RE: DRAINAGE PLAN FOR AN ADDITION TO CONTINENTAL MACHINING CO. (E17-D33)
ENGINEER'S STAMP DATED 1/22/93.

AN ADDITION TO
CONTINENTAL MACHINING CO.
6824 WASHINGTON STREET, N.E.
ALBUQUERQUE, NEW MEXICO

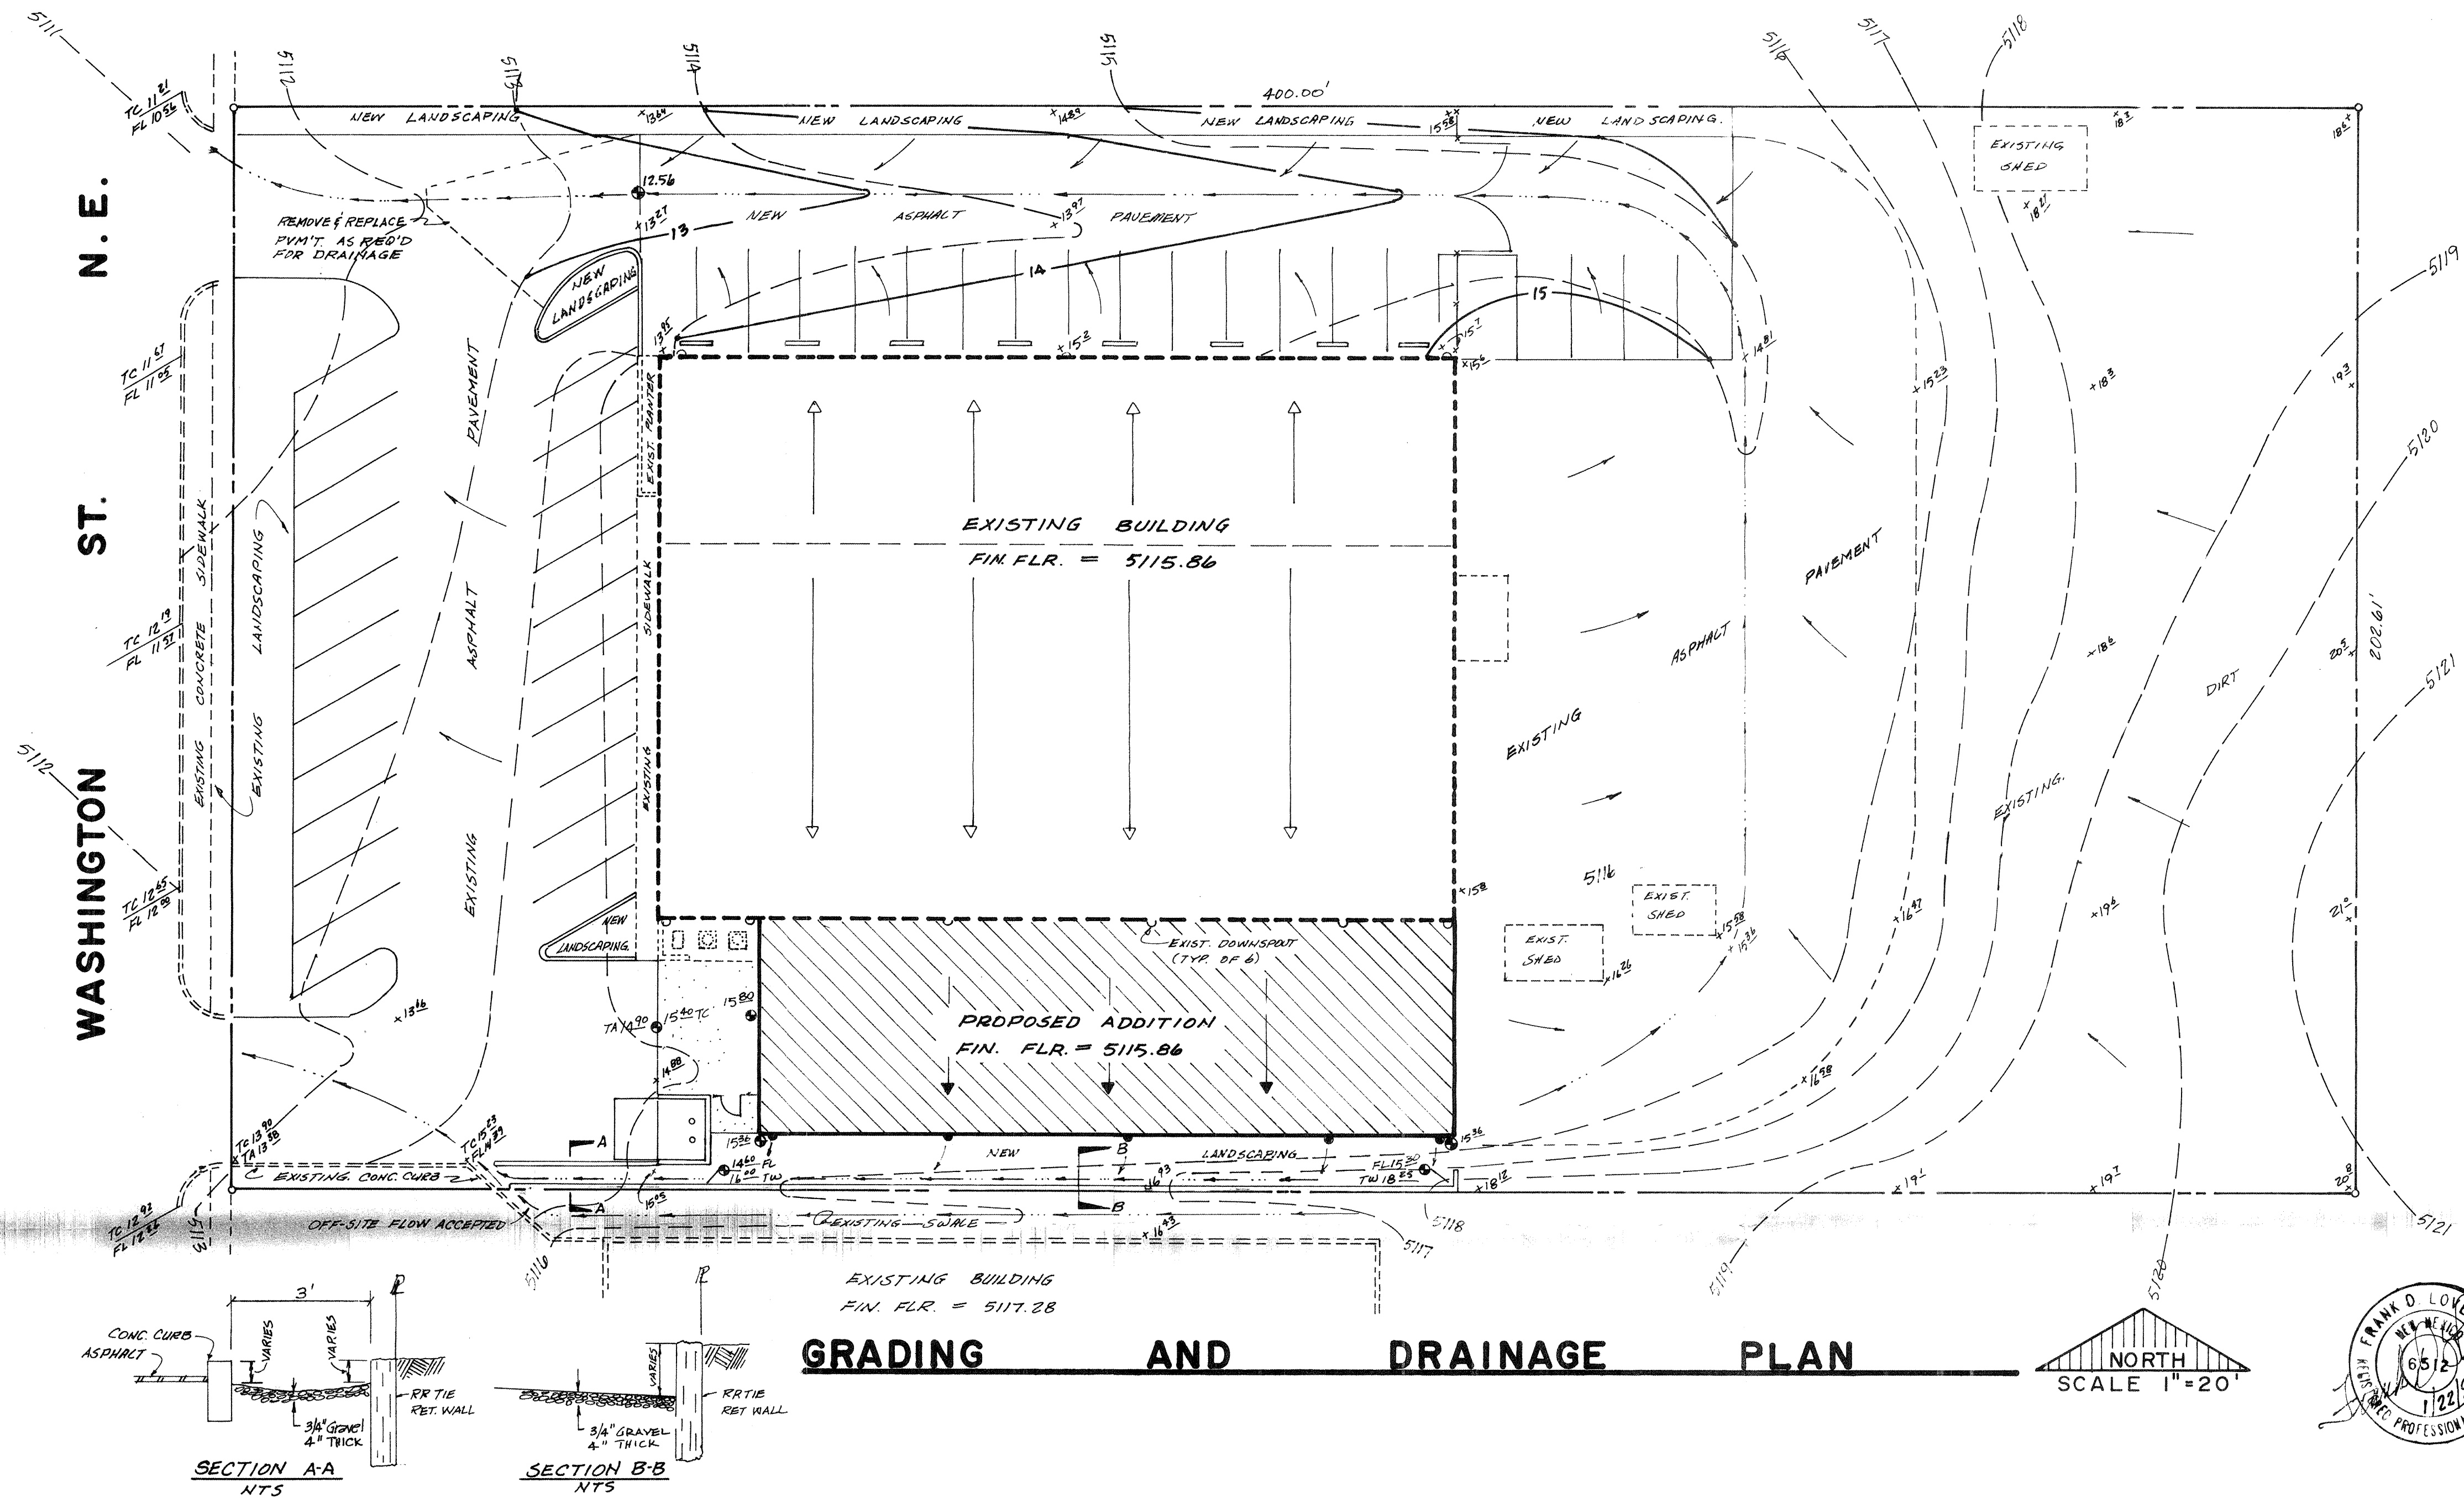
Based on the information provided on your January 22, 1993 submittal, the above referenced site is approved for Building Permit. Please advise your client that some type of plastic membrane will need to be placed at the bottom of the proposed swale.
